Revision	Date	Description	Initial	Checked
1	04/03/19	ISSUED FOR DA MODIFICATION	BS	DOMA

**42 Honeysockle Drive,  
Newcastle**  
General Arrangement Plan  
Ground Floor

Status	SKETCH
Scale	1 : 150 @ A1
Drawn	BS
Checked	DOMA
Project No.	s12109
Plot Date	29/03/2019 5:25:27 PM
Plot File	42HONEYSUCKLEDRIVE_ARCH
Drawing no.	SK.03.101
Revision	1

**42 Honeyuckle Drive**  
**42 Honeyuckle Drive,**  
**Newcastle**  
 General Arrangement Plan  
 Level 04

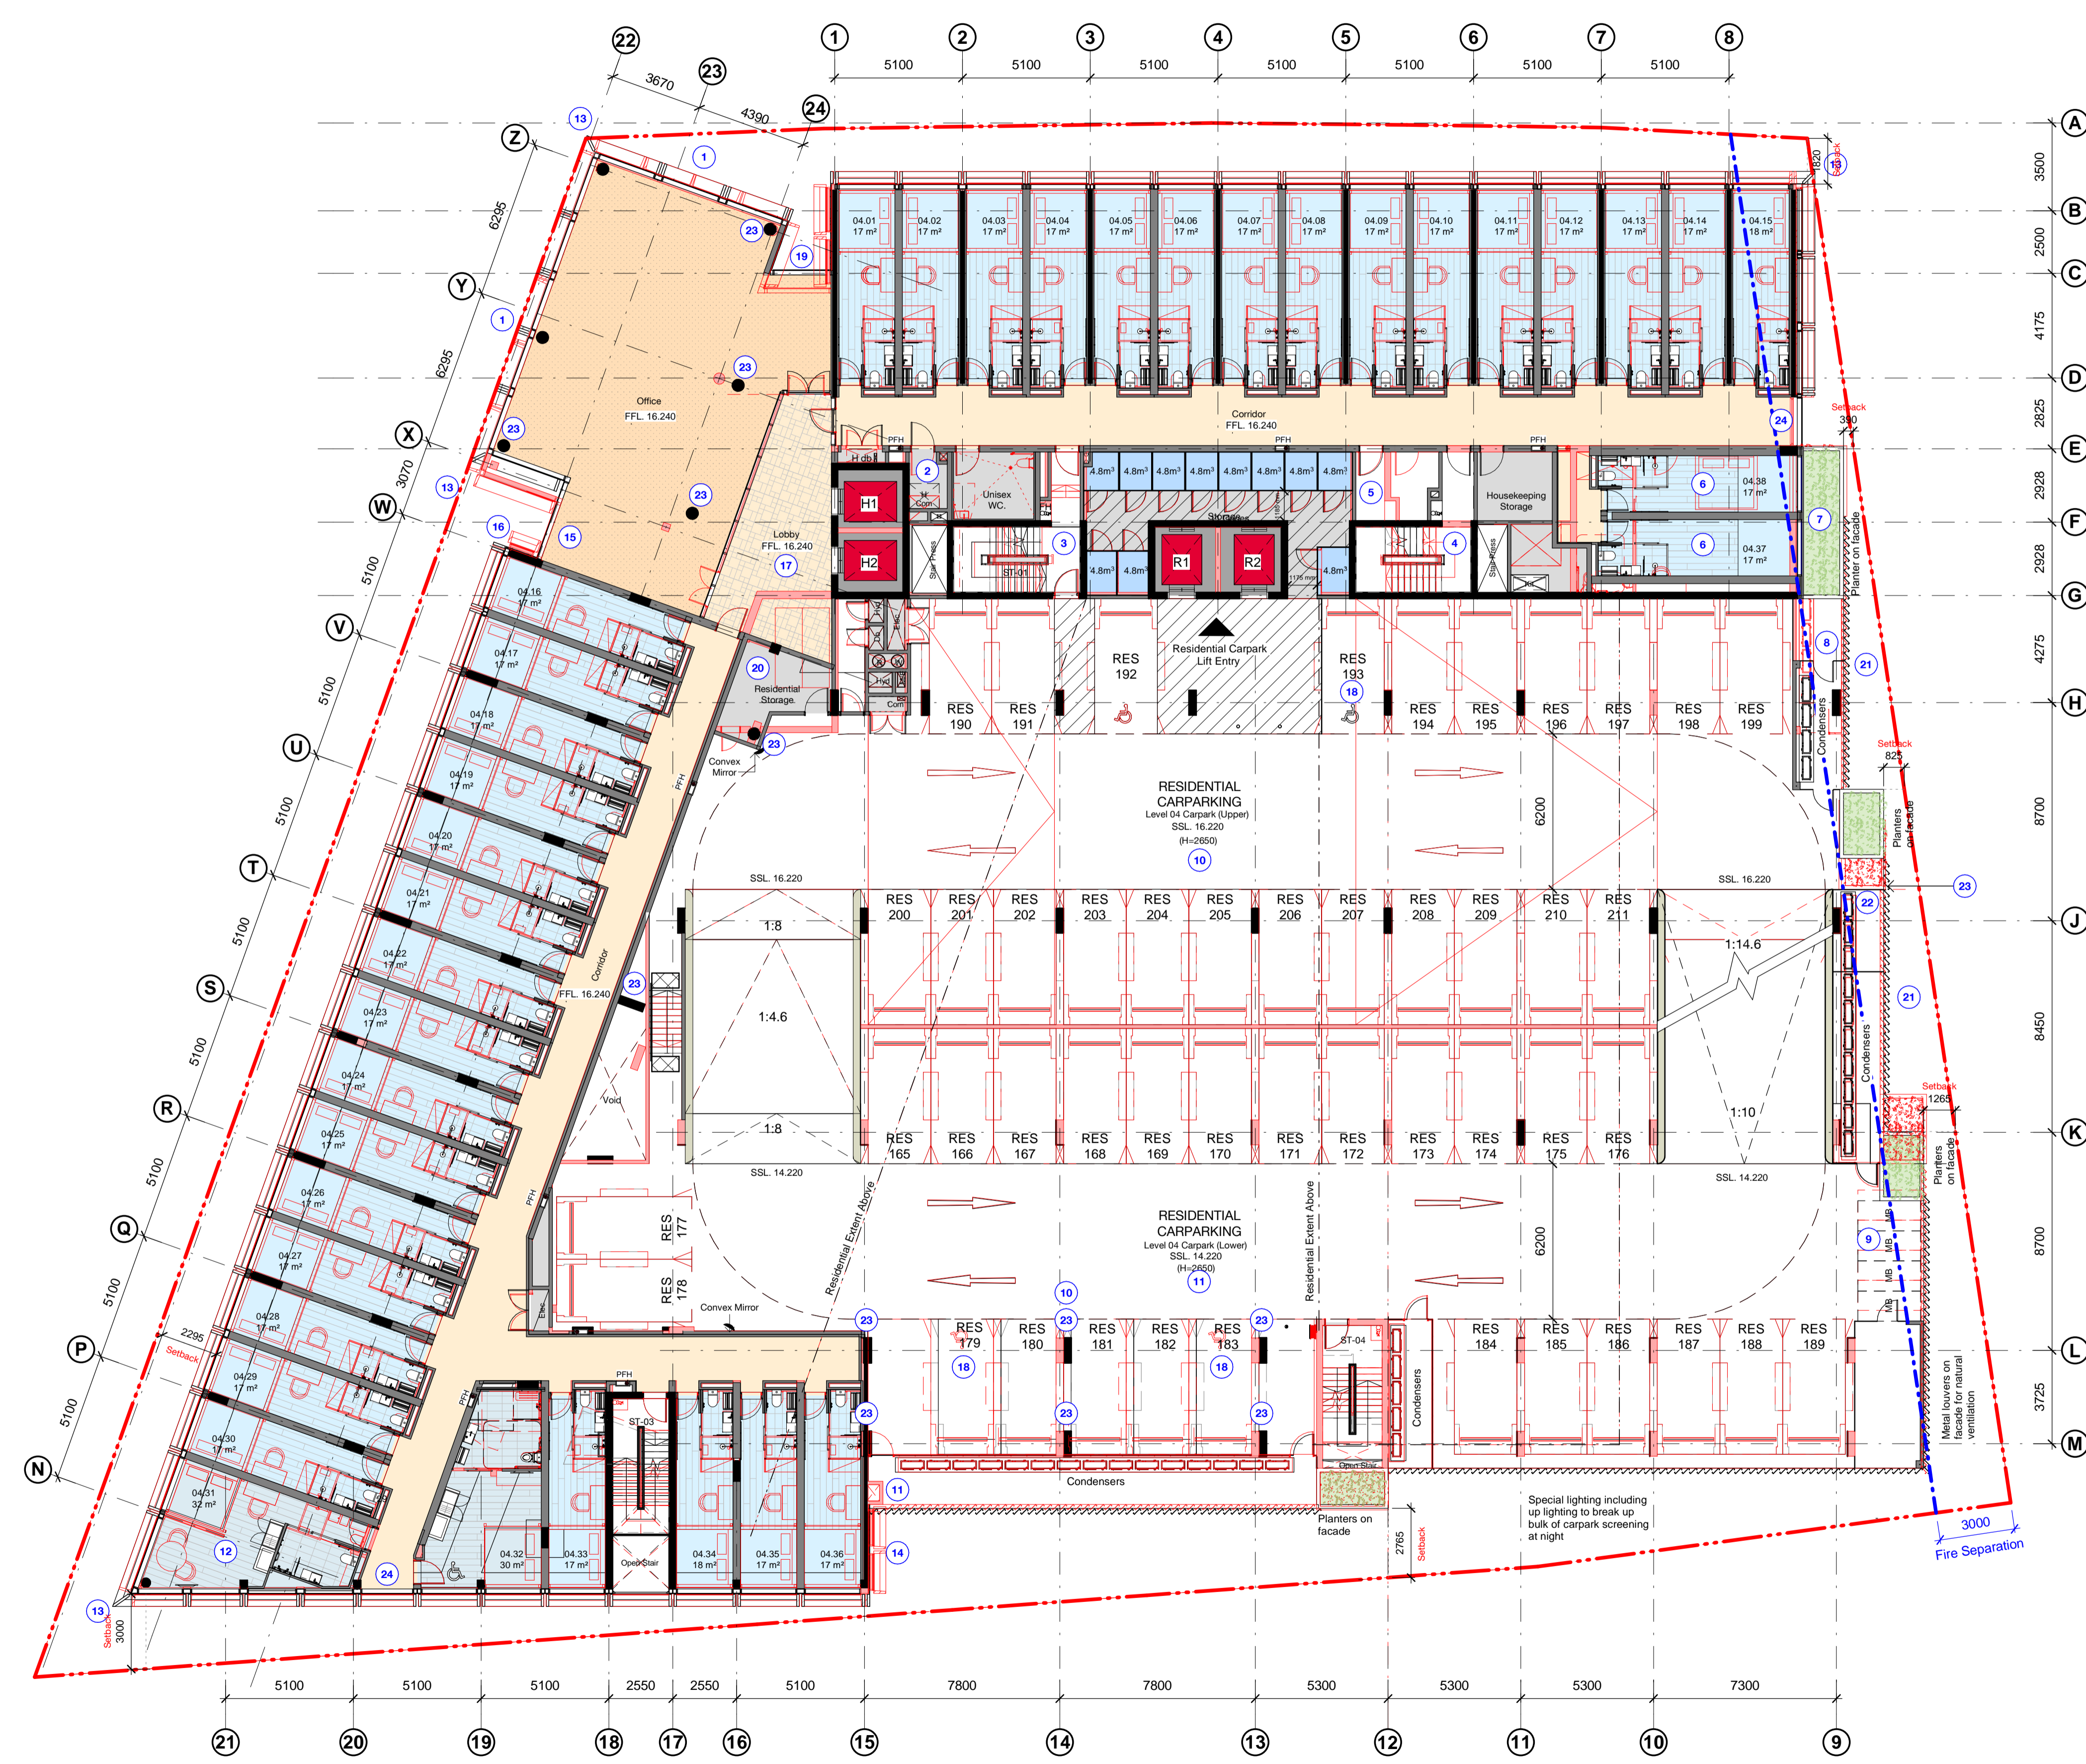
Schedule of Changes	
Level 04	
1.	Facade articulation modified to NW/NE Common Area
2.	Service room behind Hotel lifts modified.
3.	Stair ST-01 egress path modified.

4.	Stair ST-02 mirrored.
5.	Store room north of Stair ST-02 modified.
6.	2 x Additional Hotel rooms provided in lieu of Access. Hotel room.
7.	Exterior facade between grid E-G (East carpark) modified to suit 2 x additional Hotel rooms.

8.	Condenser zone (East carpark) at grid H modified to allow maintenance access for planter box.
9.	Motorbike parks between grids K-L (East carpark) shifted.

10.	6 x Parking spaces between grids 13-15 moved east.
11.	Riser at grid 15 (South carpark) deleted.
12.	Hotel room at SW corner redesigned.
13.	Facade fin corner detail modified.

14.	Facade panels deleted along grid 15 (south carpark facade)
15.	Common Area slot between grids W-X widened.
16.	Facade panel deleted at SE corner of Common Area slot.

17.	Hotel lobby design modified.
18.	Parking space typology rearranged.
19.	Facade slot extent and panelisation modified at NW corner between grids 1 and 24.

20.	Room at NW corner of carpark modified.
21.	Eastern facade extends between grids F-K modified.
22.	Condenser zone (East carpark) between grids J-K modified.

23.	Column moved/modified.
24.	Fixed glazing system to corridor end in lieu of louvred system.

**42 Honeysuckle Drive,  
Newcastle**  
General Arrangement Plan  
Level 05 Parking

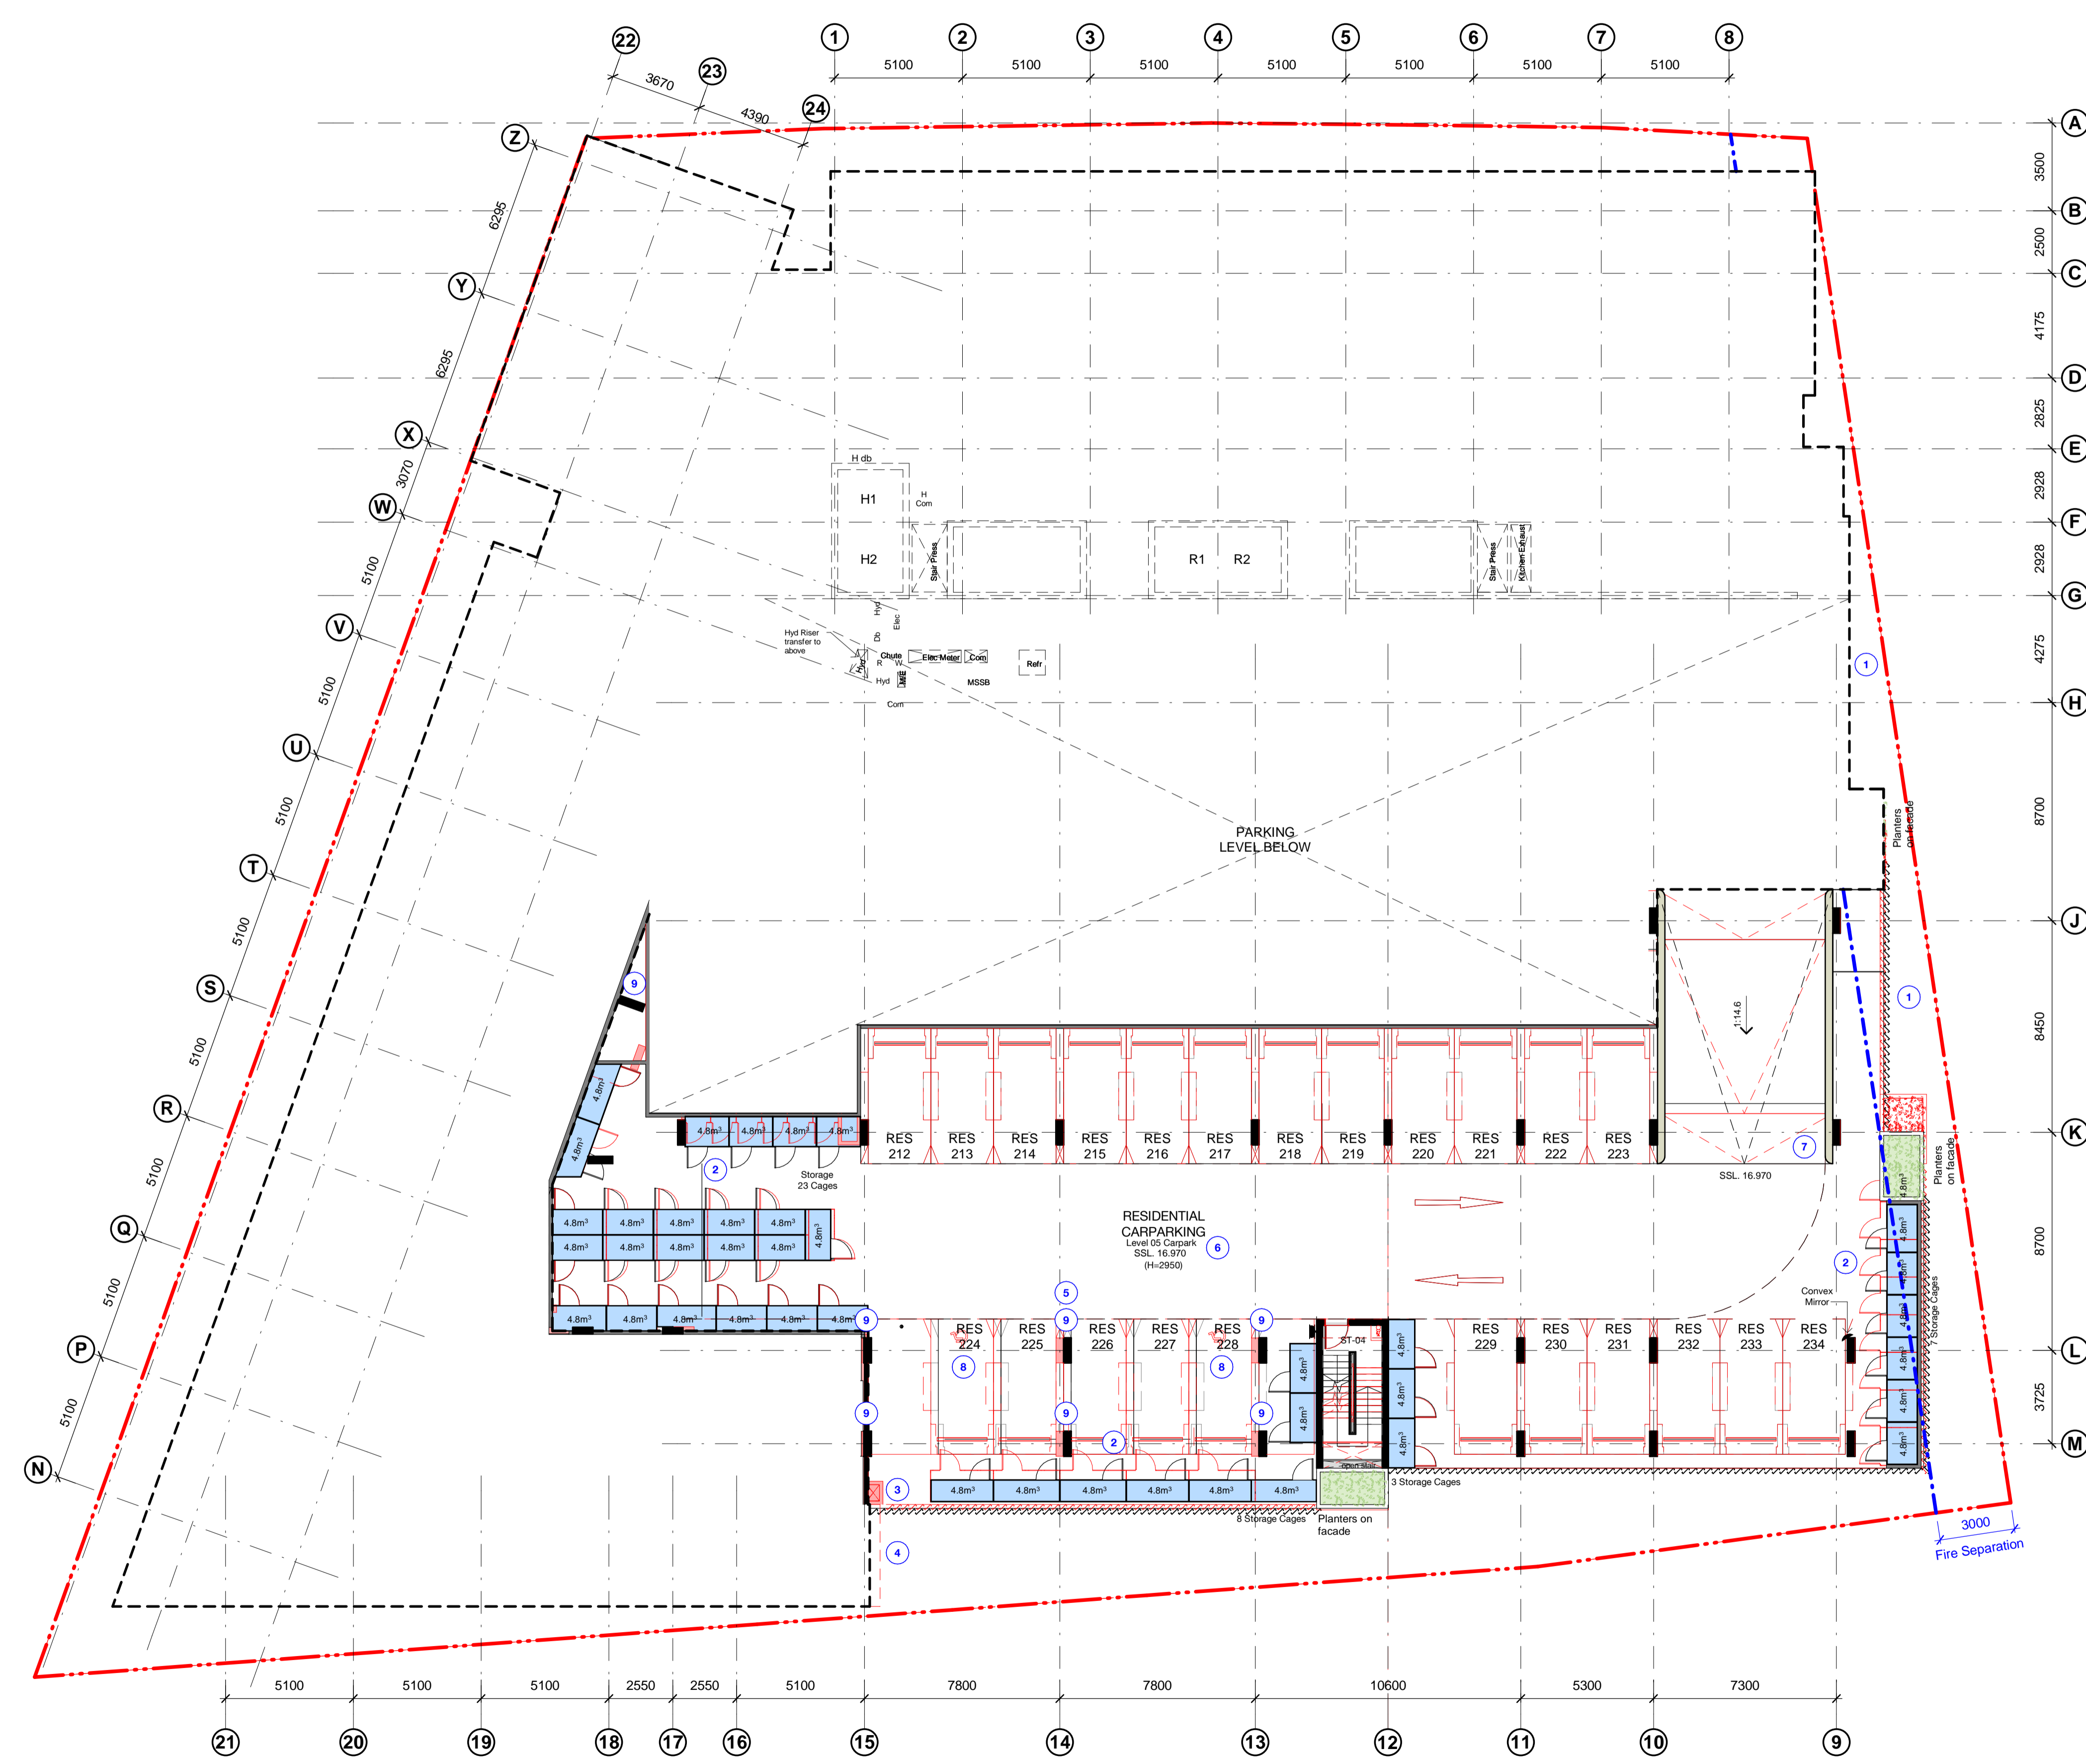
Schedule of Changes	
Level 05 Parking	
1.	Eastern facade extents between grids F-K modified.
2.	Storage units rearranged/moved.
3.	Riser at grid 15 (South carpark) deleted.
4.	Facade extent along grid 15 (south carpark facade) updated.
5.	5 x Parking spaces between grids 13-15 moved east.
6.	Level 05 Carpark SSL lowered.
7.	Carpark ramp extent modified.
8.	Parking space typology rearranged.
9.	Column moved/modified.
